Final Report – Design Review Committee on Village at Squaw Valley

The task before the Squaw Valley Design Review Committee (DRC) was to analyze the Design Standards provided in Appendix B to the Village at Squaw Valley Specific Plan (Specific Plan), and, where appropriate, make recommendations for modifications and/or additions.

Figure 2 : Village at Squaw Valley VC-C Layout, Separations, and Heights – SVRE Response to DRC Sept 2015

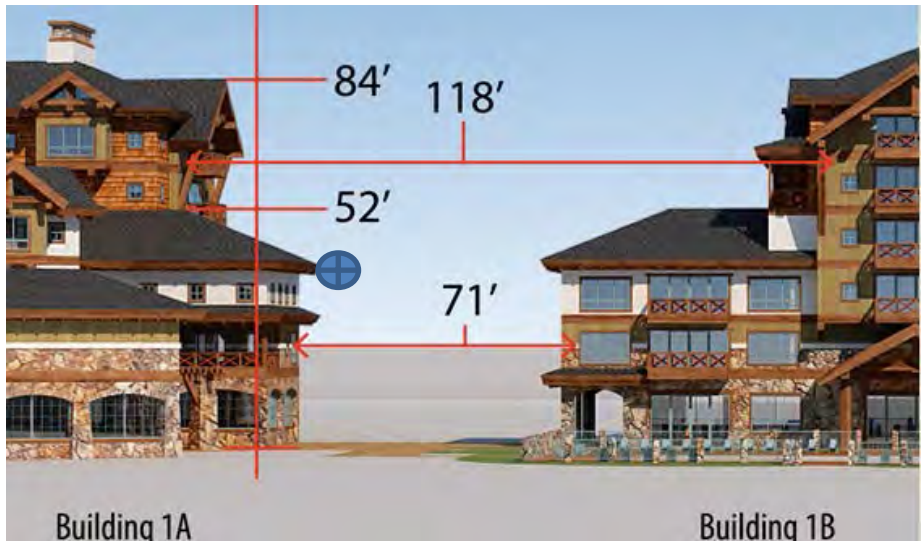
As can be seen in Figure 2, the applicant’s revised layout for VC–C (September 2015) has substantially opened up the separation between buildings, and in most instances, the separation exceeds the minimum of 40 feet for passageways.

SVRE Response: Agreed (clarifications and/or differences have been incorporated)

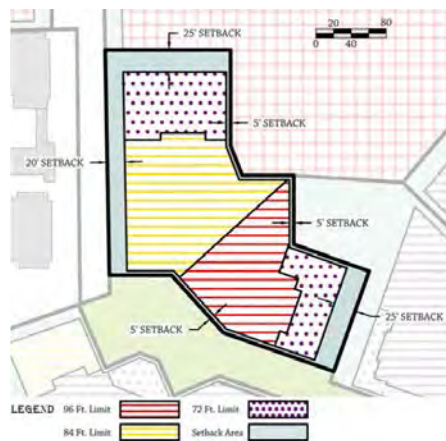
A graphic helps to explain this.

At the pedestrian plaza level, the building separation is 71 feet, thereby dictating that the height of the adjacent wall, measured from the pedestrian level to the top plate (the \oplus symbol in the above graphic), must be no more than 56.8 feet ($0.8 \times 71 = 56.8$). The opposing stepbacks are 118 feet apart, so the maximum height to that top plate must be no more than 94 feet.

SVRE Response: Agreed (clarifications and/or differences have been incorporated)

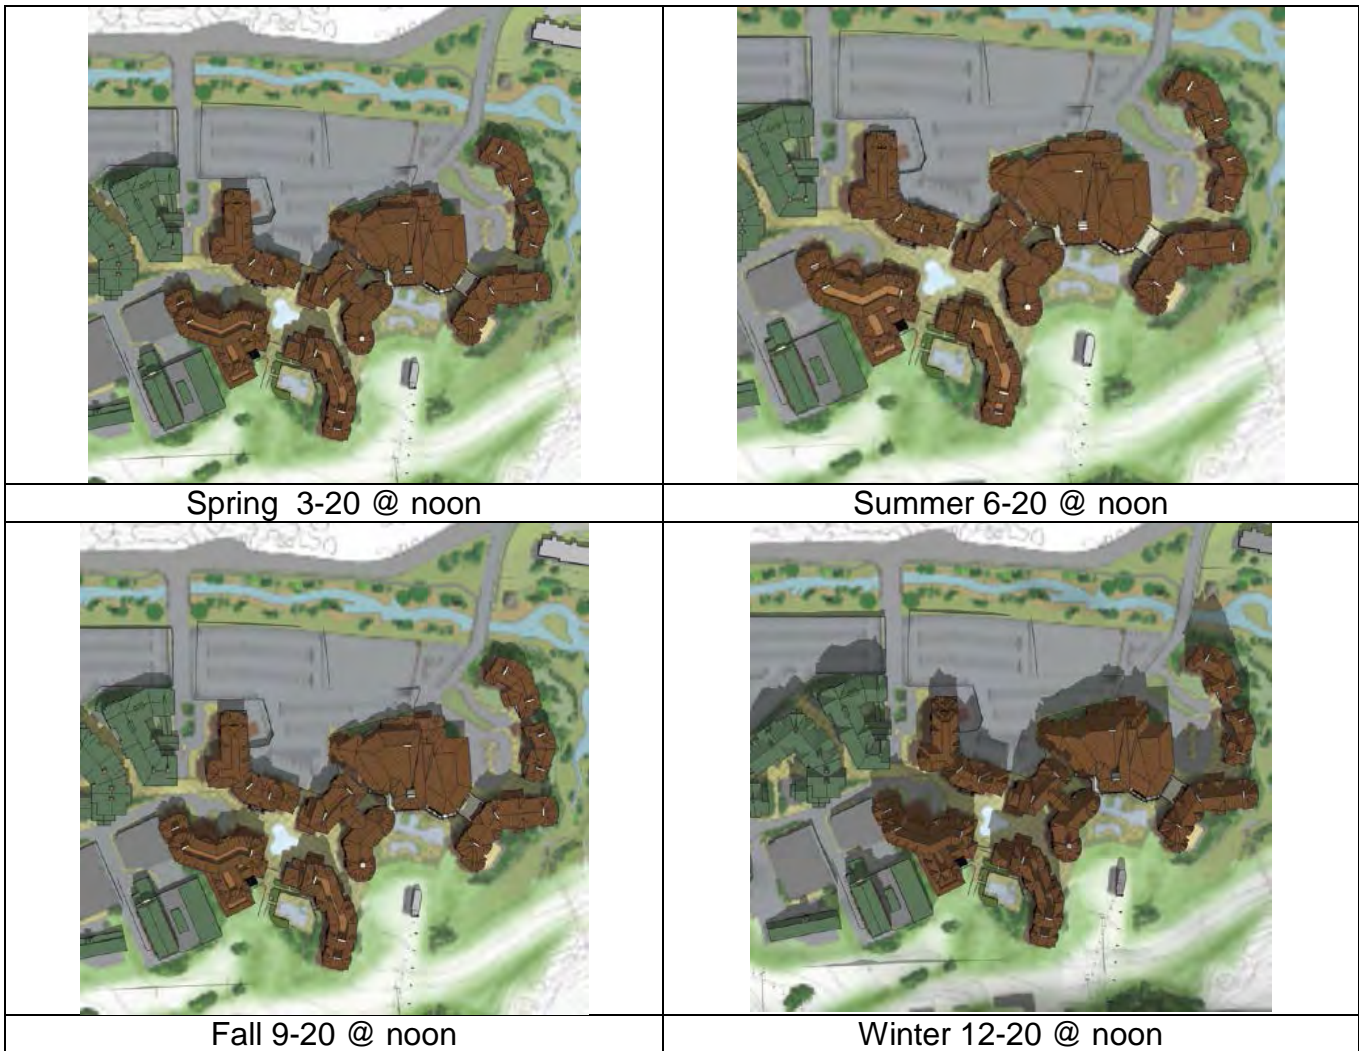
4. Pedestrian Plaza – lot 33 is designated as an open space area, and the impression is that it is to be a main gathering area and would contain an ice rink, as is so designated in Figure 4.1 of the Specific Plan. However, this lot is extremely narrow, and often shadowed throughout the year, especially in winter – a prime tourist season (ref dEIR, App F Shadowing). The DRC felt that either the applicant should give up on Lot 33 being a gathering area, or preferably, size it more appropriately.

- The Village Core–Commercial shall be comprised of a network of pedestrian streets and landscaped corridors, which shall converge at the **main pedestrian plaza** and shall be populated with smaller gathering spaces, passive and active recreational nodes, and other points of interest
- This main public pedestrian plaza shall be prominently located, a minimum of .75 acres in size, have open access, and be included within any VC–C development. Referring to the Sept 2015 SVRE VC–C layout (Figure 2) this plaza would comprise the center section of Lot 33, the passageway between building 1A and 1B, and the hardscape area between buildings 1A and 1B (See figure below).

SVRE Response: Agreed (clarifications and/or differences have been incorporated)

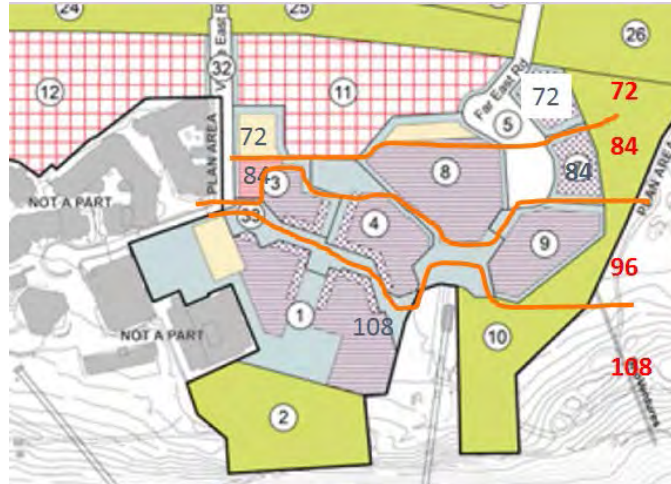
2. Building Height Arrangement – Again, the Design Guidelines included an objective that was to be encouraged: *B.5.2 Incorporate varied Building Heights to preserve key views of surrounding mountain peaks.* But the allowable heights of the buildings, especially in VC-C, would obstruct these views. In particular, the DRC objects to the appearance of the MAC dominating the entry scene and obstructing the mountain views. This is evident in the large image below taken from an applicant-prepared animation (the small image shows the view line). The building on

the left (Building 6) also was very dominant in the animation, but the applicant has indicated that its height has subsequently been lowered from 72 feet to 56 feet (See Figure 2).

The DRC felt that the view obstruction could be minimized by arranging the maximum allowable building heights in a stepped manner, as shown in this image from Mt. Tremblant with shorter buildings in front, away from the mountain, and taller buildings in the back, closer to the mountains.

The DRC decided to require this arrangement.

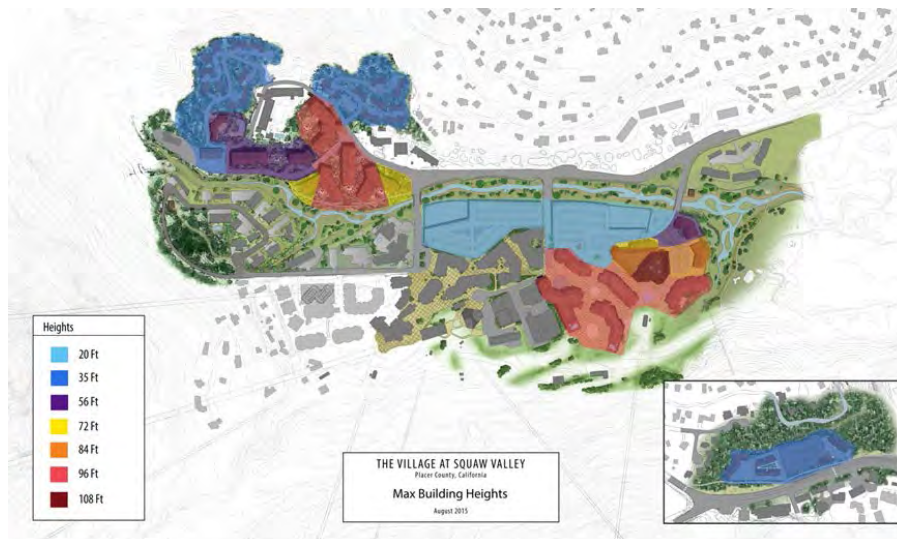
An example of how these step boundaries might appear for VC-C was created for illustrative purposes (this graphic was developed from a graphic included in the October 2014 Specific Plan).

The DRC does not accept this proposal, and remains at odds with the applicant on this recommendation. There is no height stepping from Buildings 3 and 4 to Building 1A and 1B, and the MAC remains a problem. While the northern most section of the MAC has been reduced in height, the southern 108-foot tall section still dominates the entry and street view, and its view line hits the Snow King mountain side at least 100 feet higher than other view lines. The DRC recommends that the MAC fit in with the step height arrangement by either being moved or lowered in height.

SVRE Response: SVRE agreed to the concept and presented the exhibit below

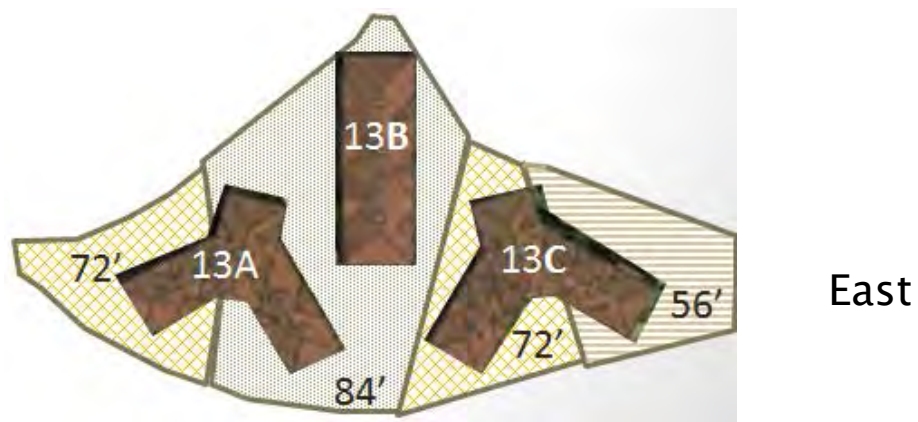
The image below from the Base Camp model highlights the three buildings of Lot 13 – Building 13C to the East (left in image) and 13A to the West (right in image).

The DRC concern was the allowed height profile of Building 13C. From the Design Guidelines Lot 13 development standards (page B-26), the entire building could be as high as 96 feet. It was felt that such a tall building will appear overwhelming as one approaches the VC-N area along Squaw Valley Road, and its profile will block the view to the Tram Face to the west. This was confirmed by the applicant at the DRC presentation on August 17th, even though the easternmost section of building 13C had been lowered to 72 feet.

- Buildings in VC-N must abide by the Building Shape Design Standard.
- The Height Arrangement Standard does not apply in VC-N except for Lot 13. The maximum allowable heights in Lot 13 will be determined by this Lot drawing (or a close approximation thereto)

SVRE Response: Agreed (clarifications and/or differences have been incorporated)
